Cherryfield Drive, Kirkby

TN04 – KMBC Highways Consultation Response

Client:	Barratt & David Wilson Homes North West	Job No:	J326949
Date:	19 December 2024	File Name:	TN04
Prepared by:	LJ / MA	Approved by:	ME

H9305-DWH-XX-XX-DR-UD-203100

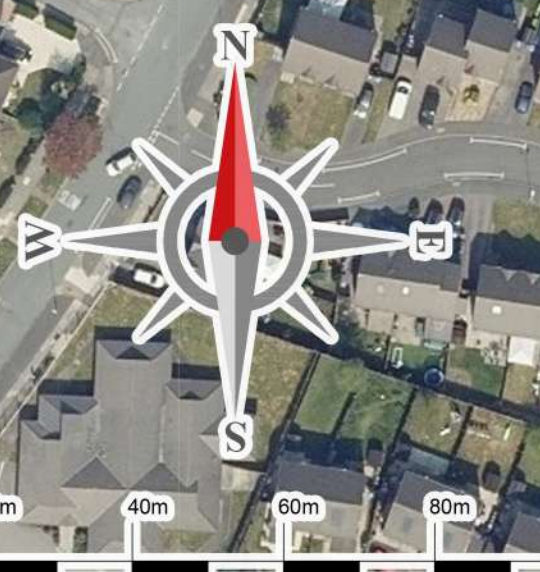
Residential shared surface roads should have a design speed of 15mph. Horizontal deflection will be required to ensure speeds are kept low. This can include the use of build outs/carriageway narrowings and chicanes at spacings of no more than 40m. The maximum number of dwellings for a shared surface is 25. They should generally be culs de sac or short sections (100m maximum) to ensure low traffic flows and to avoid the issues around restraining traffic speeds to that commensurate with a pedestrian environment. Vertical deflection (e.g. speed cushions) are not considered appropriate as they are not proven to reduce speeds sufficiently below 20mph, and the measures can be a hazard to pedestrians who will be negotiating the space in addition to vehicles. Flush features (painted virtual humps or different surfacing material) are considered to be supporting measures only, which may be useful for the purposes of highlighting crossing points or uncontrolled junctions, but are not sufficient to restrain speeds without being used in conjunction with other measures.

Other internal site roads will require traffic calming for unrestrained distances over 60m, commensurate with the site wide design speed of 20mph. These features should be identified on the site plan to demonstrate they will not interfere with driveway accesses or other constraints. Including, but not limited to: B254 -B281, B194 – B217, B177 – B157, D264 – D284, D268 – D280, D330 – D319,

Transitions from roads with carriageway and footway to shared surface either missing or inadequate to allow pedestrians access from footway into shared surface without negotiating a ramp (sitewide). Revised layout does not address this at all locations e.g.D202, D173.

Driveways coinciding with ramps (speed tables) are not acceptable – e.g. plot B61

For information, the extended length of dropped kerb along Cherryfield Drive (D150-D139 is not acceptable – this will need to remain full height and be dropped at the location of each driveway access.

- **Pedestrian transition to shared surfaces** – at the transition points between roads with footway and shared-surfaces, the footway has been extended so pedestrians do not need to walk on ramps.

- It should be noted that in a number of locations the shared surface private drives are accessed off raised table junctions where the footway on the major arm is the same level as the carriageway and there are no ramps up to the shared surface on the minor arm. In these locations there is no requirement to extend the footway onto to the initial section of the minor arm. Where there is a ramp on the shared surface minor arm of junctions, footways have been continued 2m beyond the ramp to ensure a continuous level access for pedestrians.

- **Driveways conflicting with ramps** – the site layout has been amended so driveways are not located immediately adjacent to ramps.
- **Maximum dwellings shared-surfaces** – it is noted that SMBC Highways have stated that shared-surfaces should be restricted to a maximum of 25no. dwellings and should generally comprise cul-de-sacs or short sections. The proposals included sections of shared-surface that exceed 25no. dwellings – specifically in the south-east corner of the site and north-west corner of the site.

- **Dropped kerbs on Cherryfield Drive** – it is noted that an extended section of dropped kerb on Cherryfield Drive to serve private driveways would not be accepted by KMBC Highways, and instead the kerb should be dropped in the location of each driveway, with the other sections of kerb remaining at full height. **Drawing No. J32-6940-PS-012** indicates the change from verge to hardstanding, rather than the extent of dropped kerb, therefore this is accepted by the Applicant and can be addressed at the detailed design stage as part of the S278 Agreement.
